Amendment to the Application to the
North Dakota Public Service Commission
for
Consolidated Certificate of Corridor
Compatibility and Route Permit

Case No: PU-11-696

**AVS-Neset 345-kV
Transmission Project**

January 2015

Figure 5.11-4
 Basin Electric Power Cooperative
 Antelope Valley Station to Neset
 345-kV Transmission Project
 Oilfields and Coal Deposits

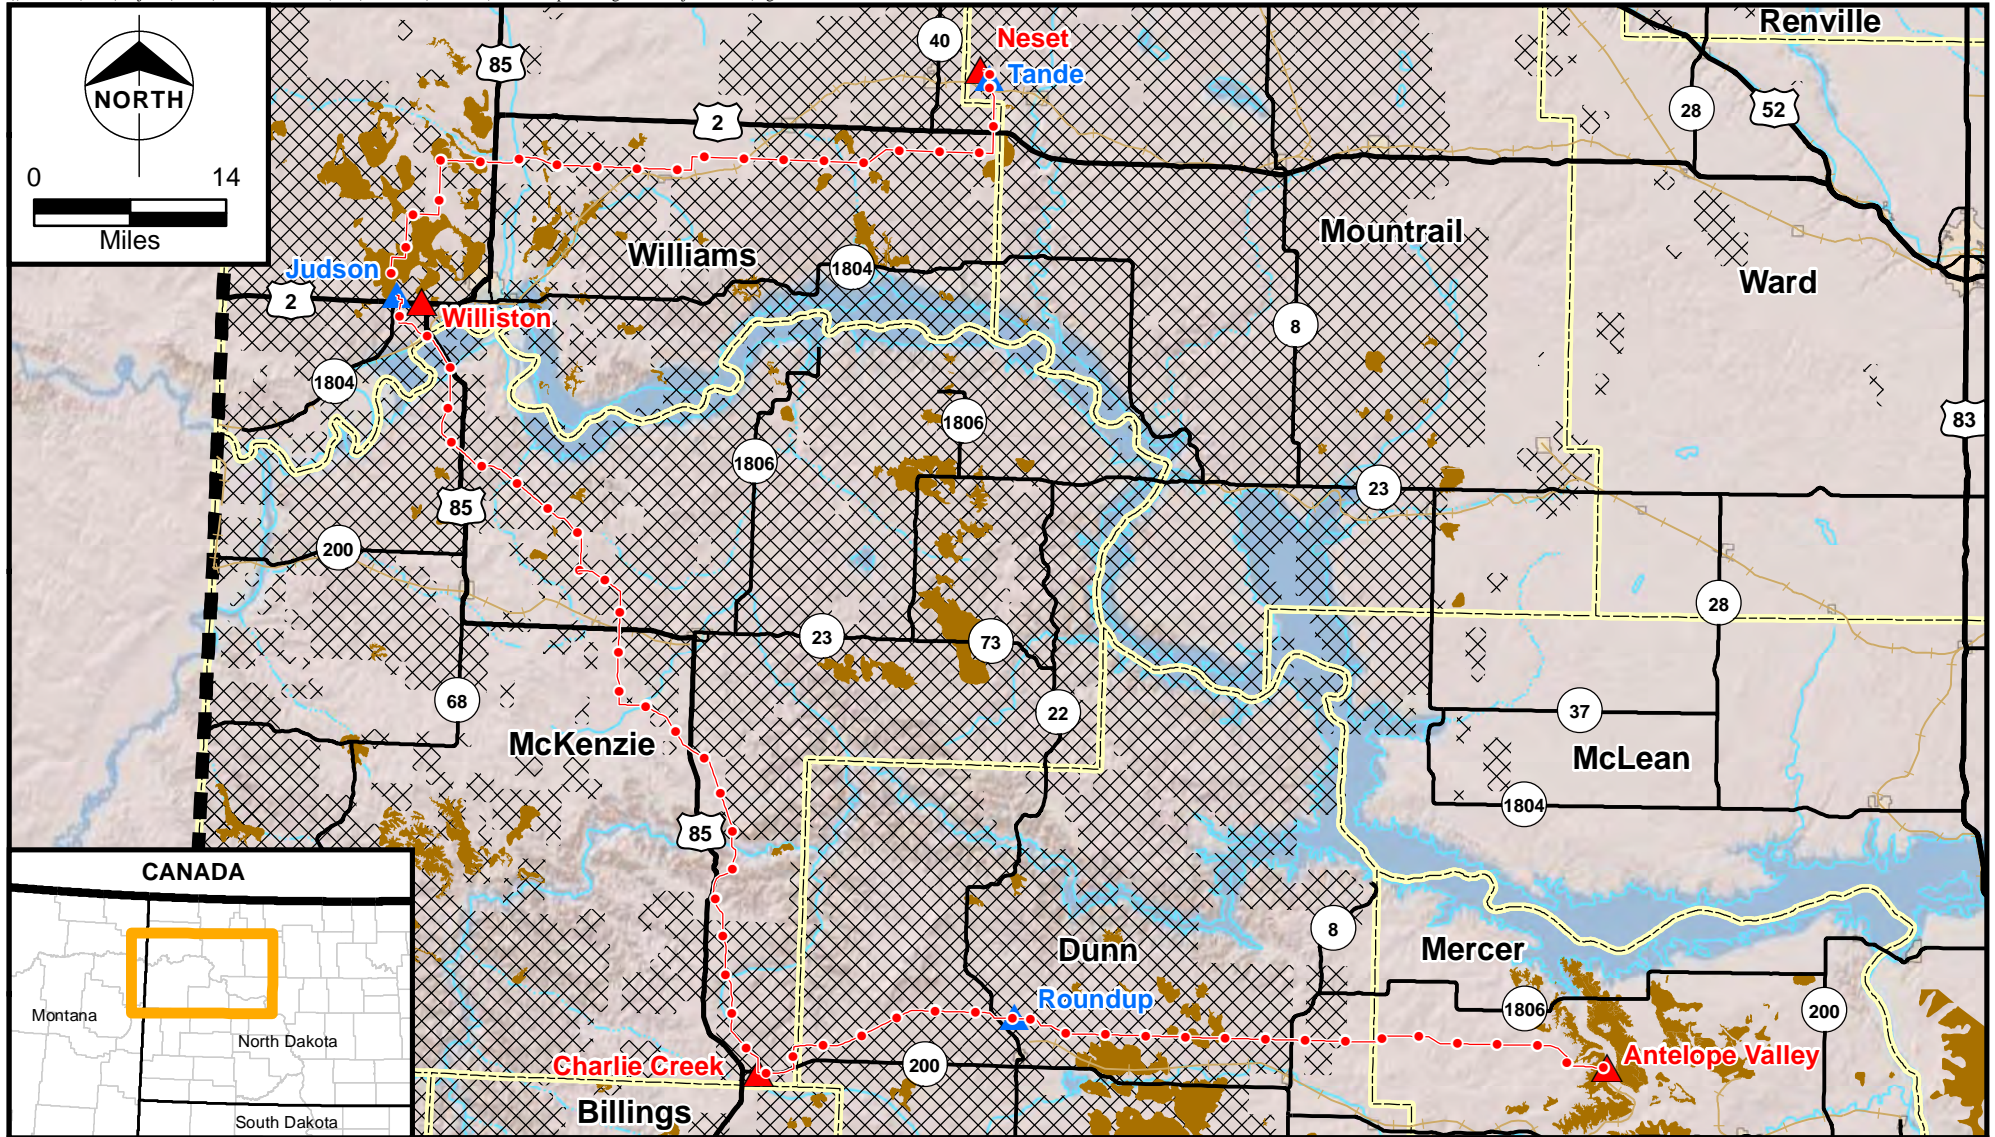
No changes from addition of proposed Roundup Substation. Figure 5.11-4 updated to include the Roundup Substation.

Figure 5.11-5
Basin Electric Power Cooperative
Antelope Valley Station to Neset
345-kV Transmission Project
Landslide Areas

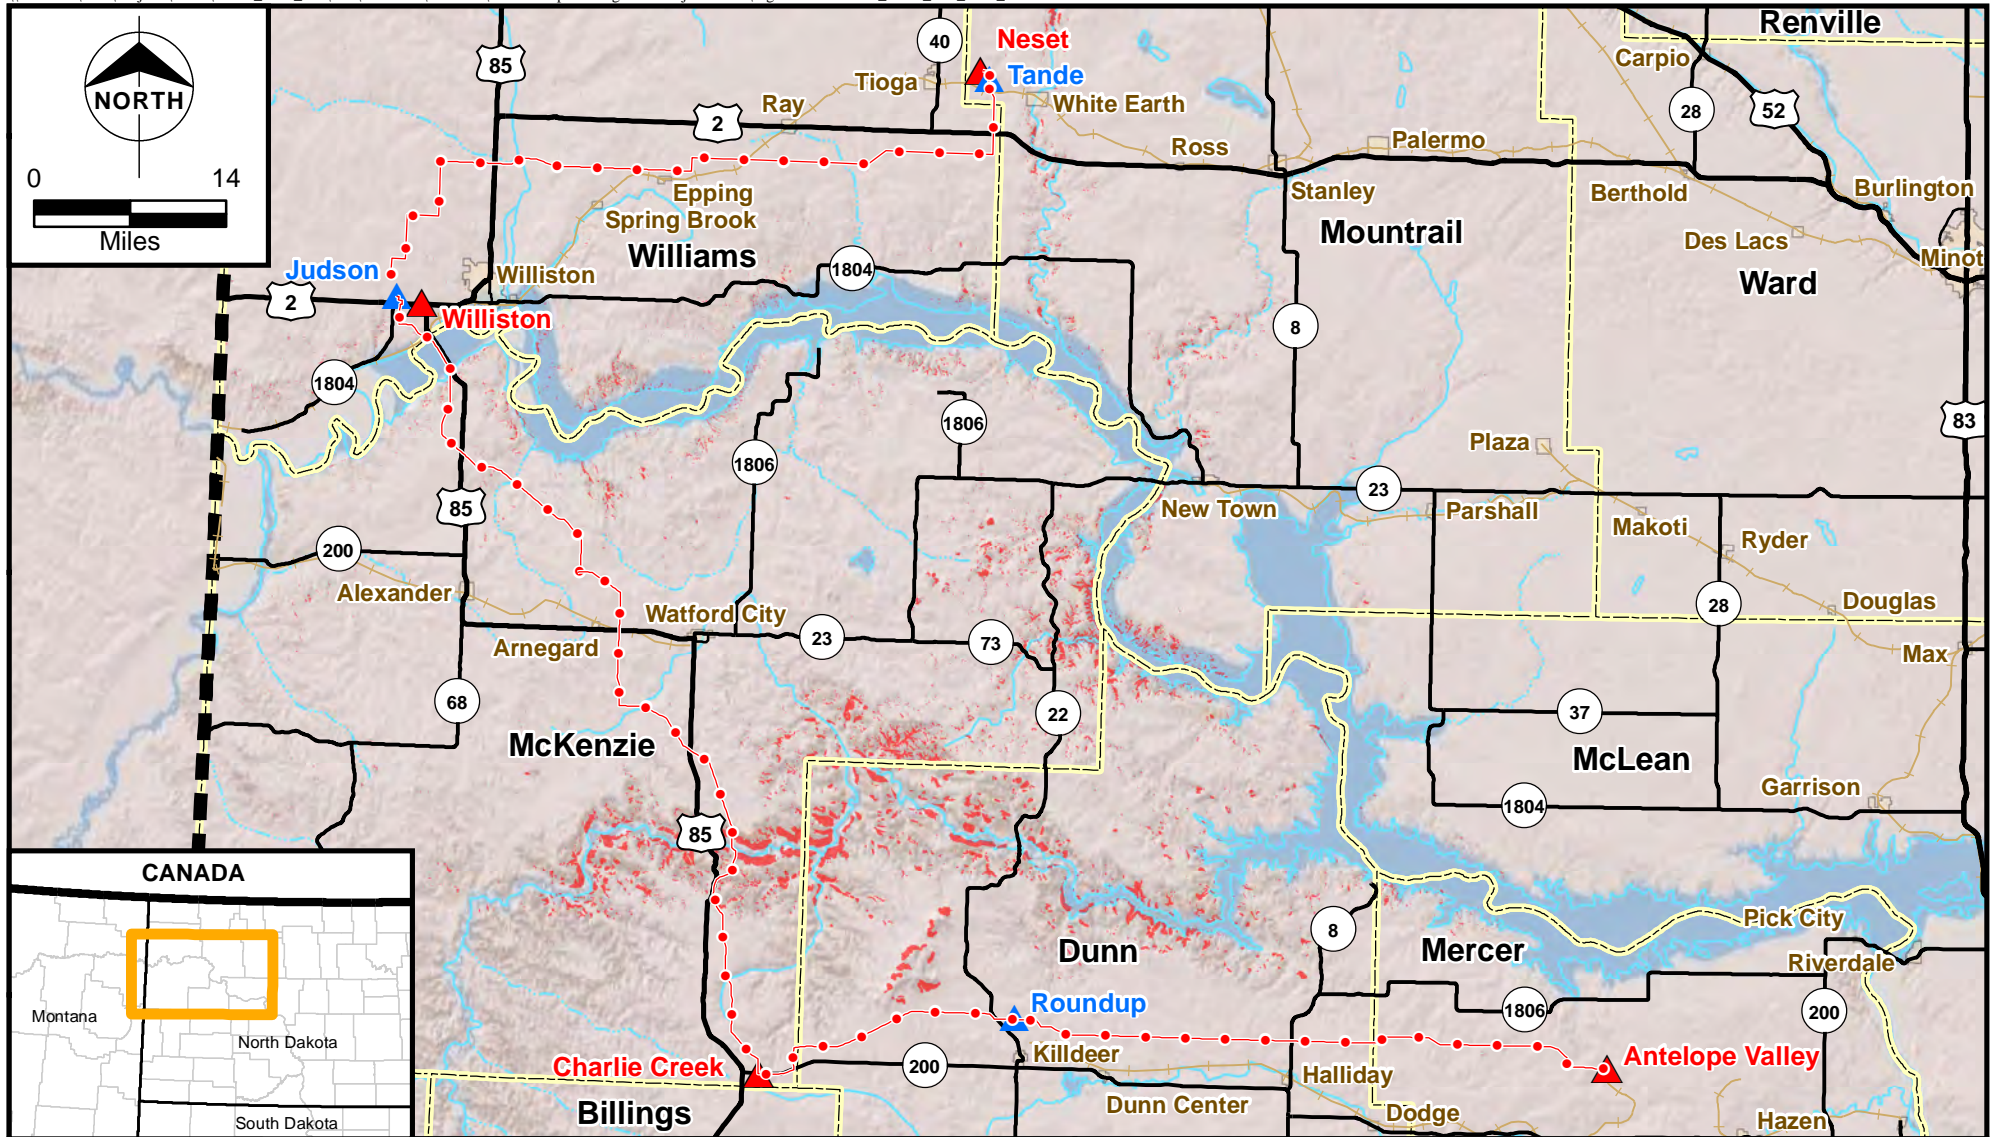
No changes from addition of proposed Roundup Substation. Figure 5.11-5 updated to include the Roundup Substation.

Figure 5.13-5
 Basin Electric Power Cooperative
 Antelope Valley Station to Neset
 345-kV Transmission Project
 NWI Wetlands

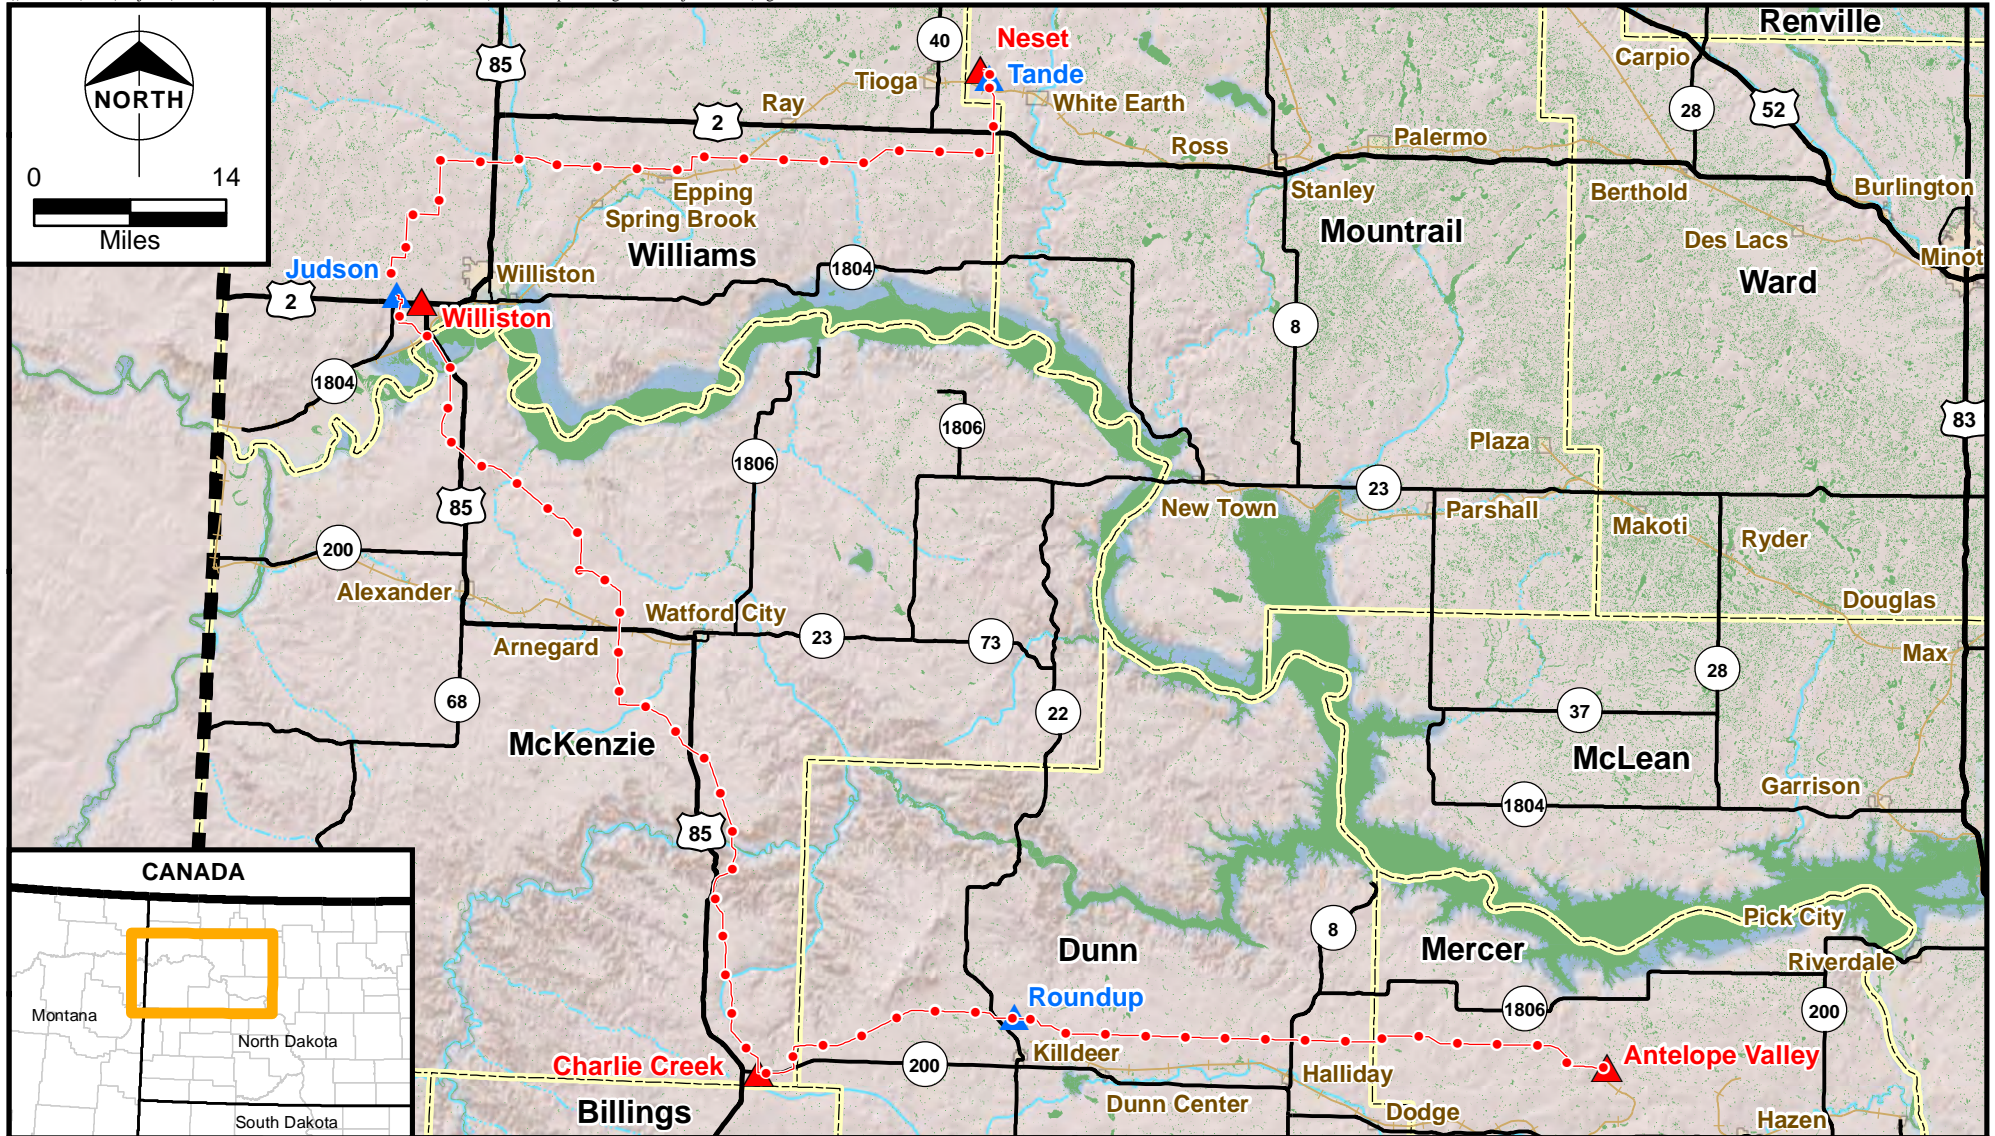
No changes from addition of proposed Roundup Substation. Figure 5.13-5 updated to include the Roundup Substation.

Figure 5.13-6
Basin Electric Power Cooperative
Antelope Valley Station to Neset
345-kV Transmission Project
Important Threatened and Endangered
Species Habitat

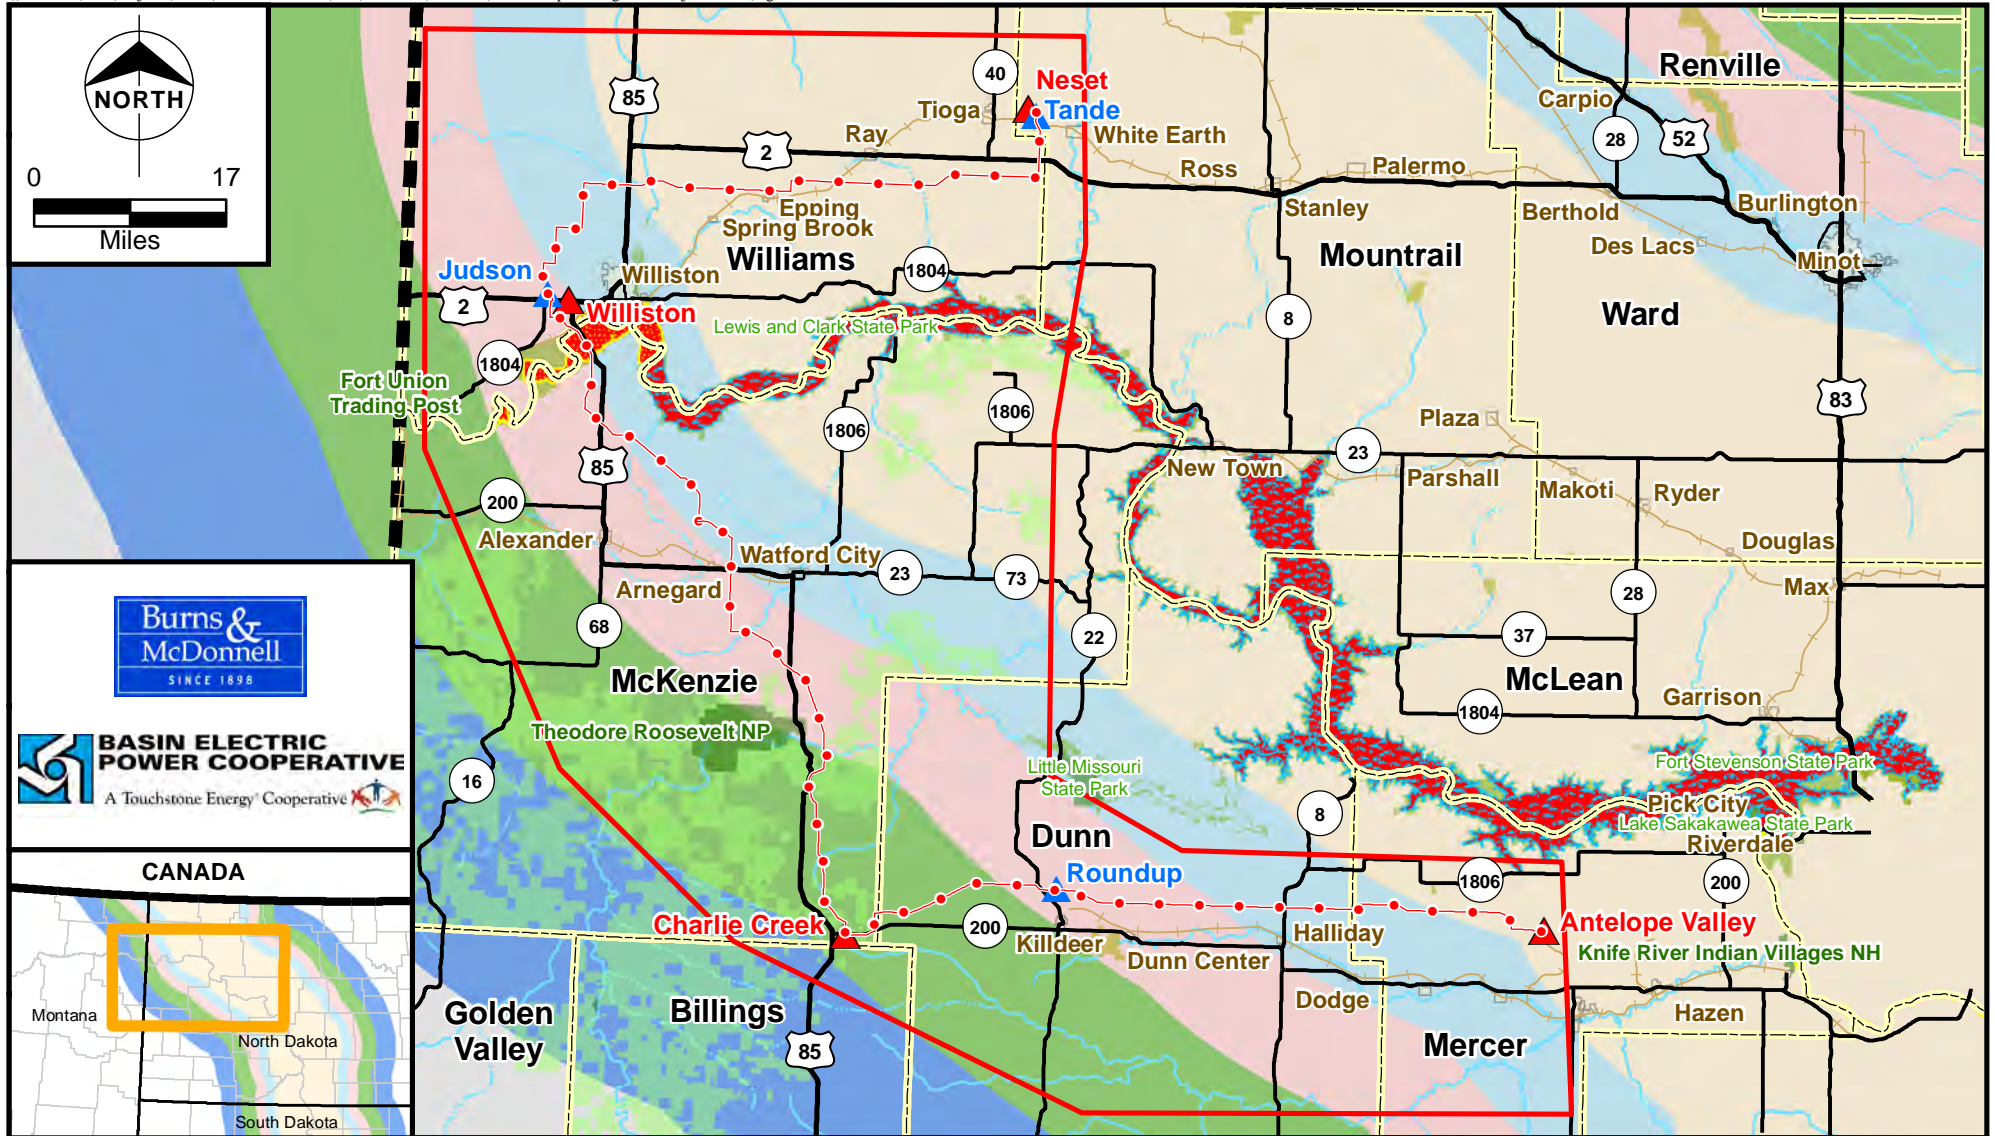
No changes from addition of proposed Roundup Substation. Figure 5.13-6 updated to include the Roundup Substation.
